February 2001

Evaluation of Confining Layer Integrity Beneath the South District Wastewater Treatment Plant, Miami-Dade Water and Sewer Department, Dade County, Florida

**Idaho National Engineering and Environmental Laboratory
Geosciences Research Department
Idaho Falls, Idaho 83415**

The United States Environmental Protection Agency – Region 4 requested that the Idaho National Engineering and Environmental Laboratory (INEEL) review available information that describe the geology, hydrogeology, and geochemistry at the SDWTP, and to assess whether these data are sufficient for evaluating the integrity of the MCU.

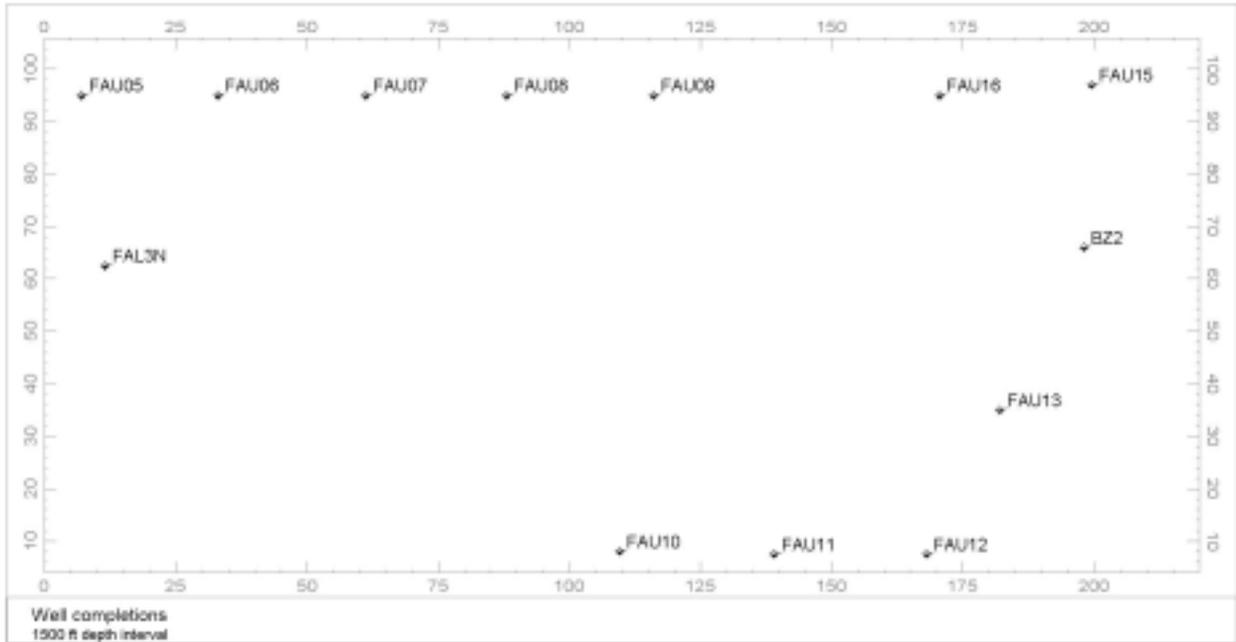
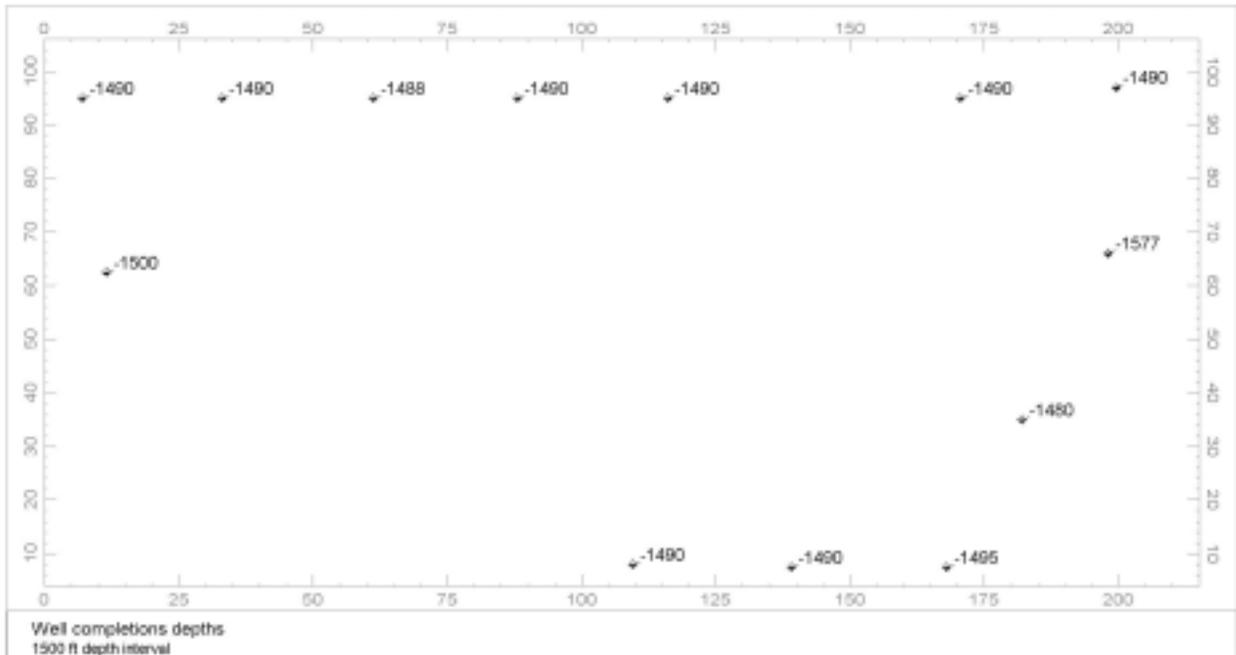
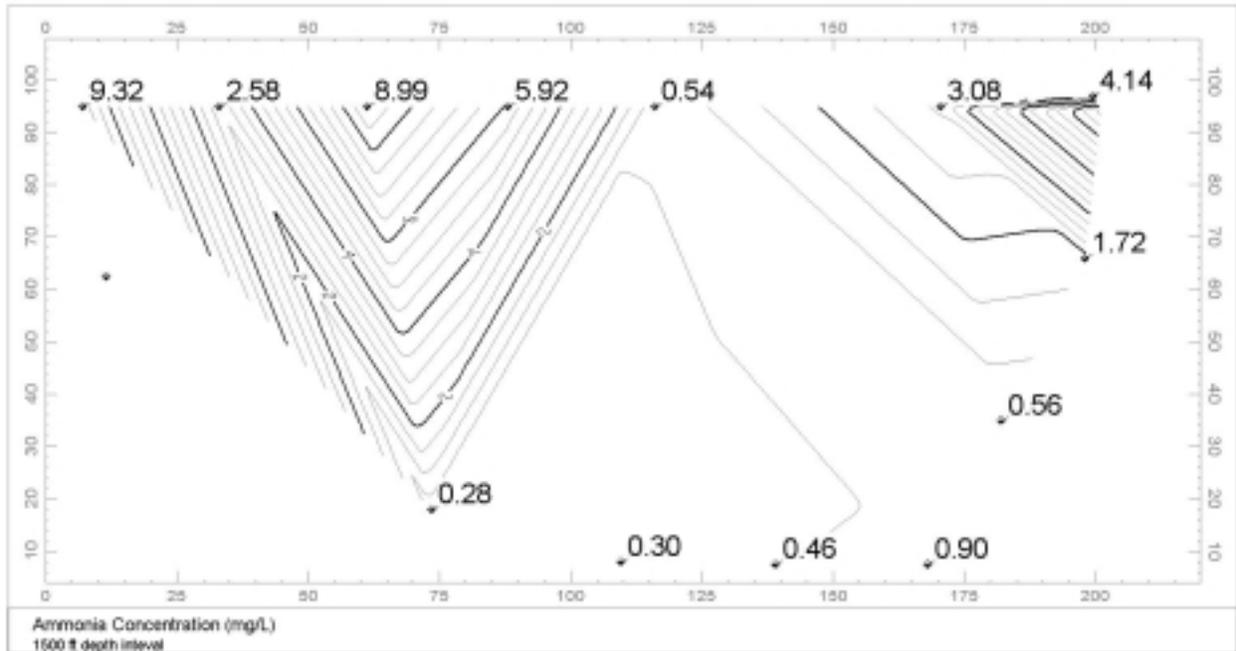
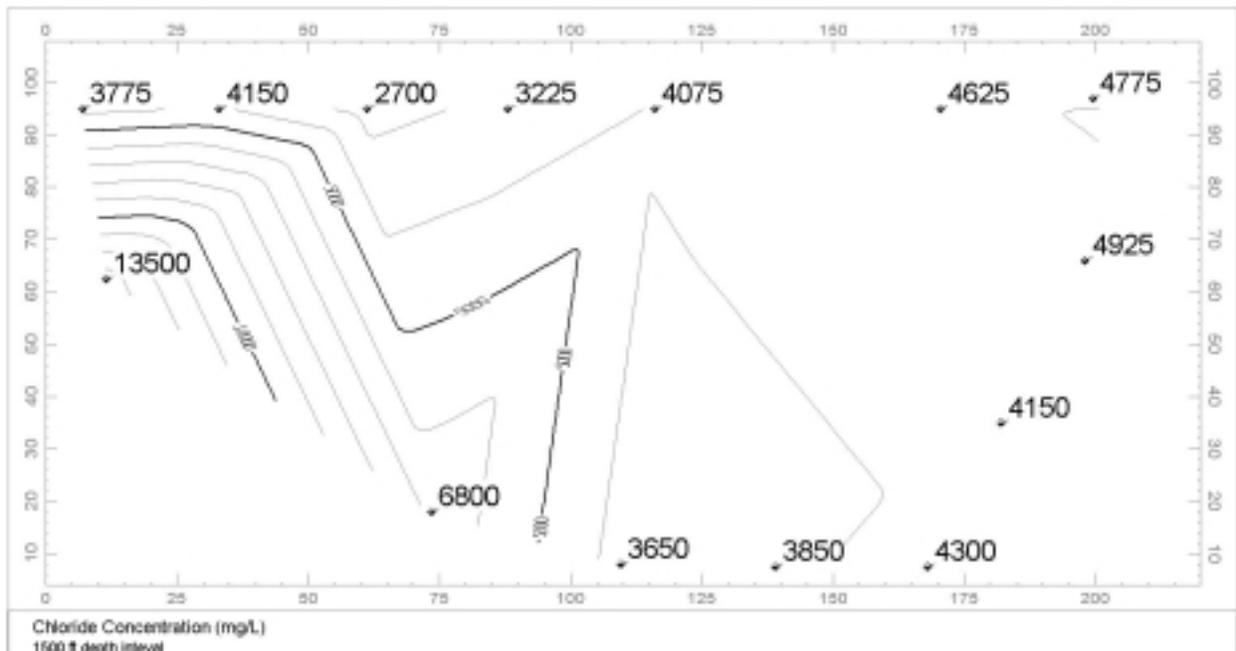
A map of wells completed at the 1,500-ft depth interval is provided in Figure 15, and the completion depths of the wells are shown in Figure 16. A map of the ammonia concentration at the 1,500-ft depth zone is provided in Figure 17. A map of the chloride concentration at the 1,500-ft depth zone is provided in Figure 18. The magnitude of the chloride concentrations in the 1,500-ft depth interval is much lower than the magnitude in the concentrations in the 1,800-ft depth interval. In the 1,800-ft interval, a distinct difference exists in chloride concentration between wells with ammonia and wells without. No such obvious relation is indicated in the 1,500-ft zone. A large variation in ammonia exists, but very little variation in chloride. The levels of ammonia are elevated in the northeast and northwest portions of the facility. The distribution at this level is not as clear as at the 1,800-ft depth interval. Point sources appear to be present in the northeast and northwest. However, some level of contamination has spread throughout the 1,500-ft zone. Note that these point sources are not located at the BZ well cluster, and thus pre-1995 leaks in BZ-3 or BZ-4 do not appear to be the only source of contamination in the 1,500-ft horizon.

Figure 19. Ternary diagram showing the evolution of groundwater at the site from the mixing of three components.

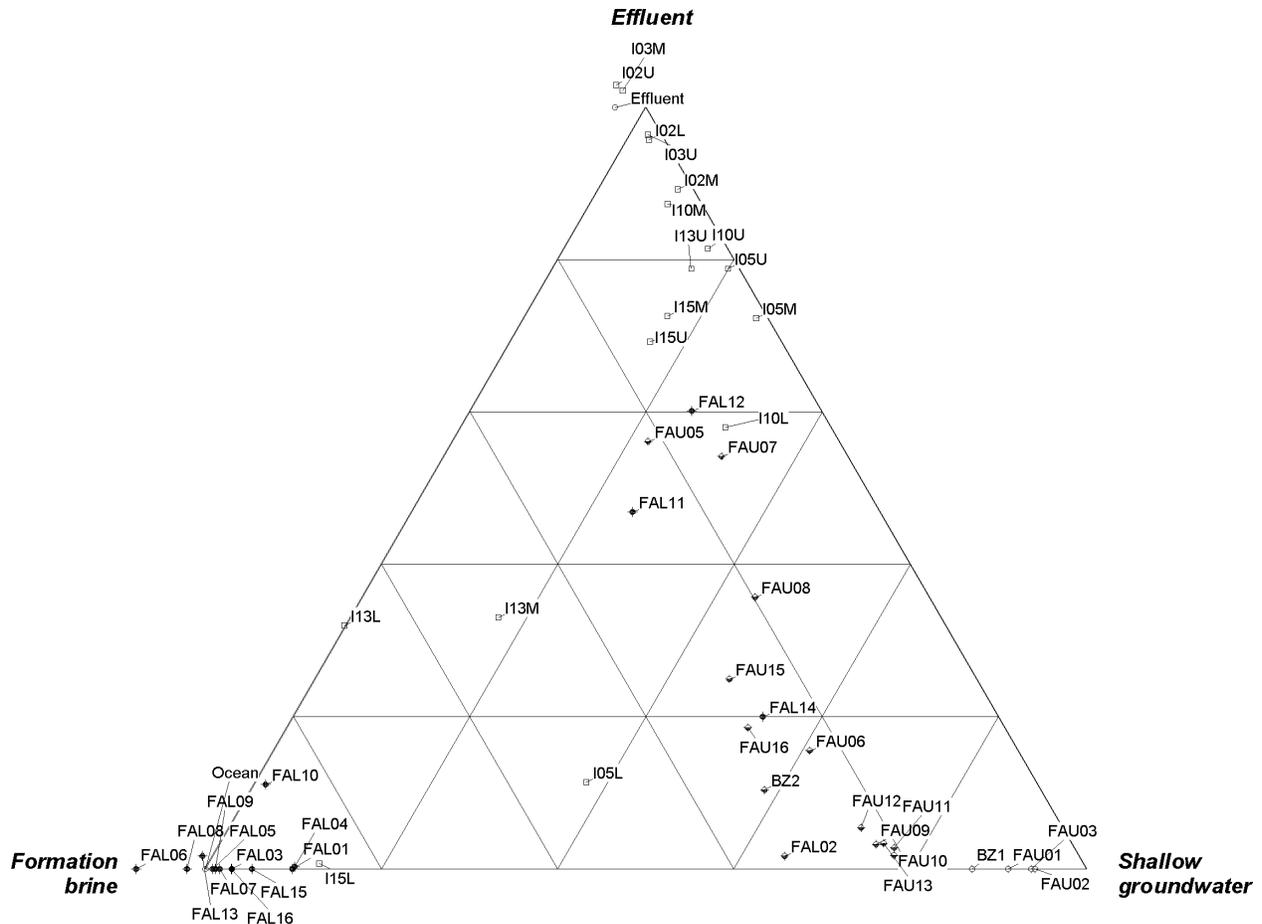
Effluent and most of the injection zone waters fall near the upper apex of the triangle indicating that most of the initial brine has been swept from the upper portions of the injection zone. Ocean water,

Waters in the 1,500 and 1,800-ft zones that showed evidence of contamination with effluent generally plot on a line between the effluent apex and the 1,000-ft zone samples. From the 1,800-ft zone, these samples are FAL12, FAL11, and FAL14. From the 1,500-ft zone, these samples are FAU05, FAU07, FAU08, FAU15, FAU16 and FAU06. Samples in the 1,500 and 1,800-ft zones lying on a line between effluent and the native water chemistry is a good indication of mixing of the two waters as an explanation of the source of contamination. The observation that the water samples from the 1,500 and 1,800-ft zones fall along this same trend, and not on a mixing line between the effluent and shallow groundwater apexes, indicates that something more than mixing between effluent and shallow groundwater is taking place. The most likely explanation is that the water that migrated upward from the Lower Floridan Aquifer to the 1,800-ft zone is not strictly effluent, but effluent that has mixed with approximately 20% ocean water, similar to samples I15U, I15M, and I10L.
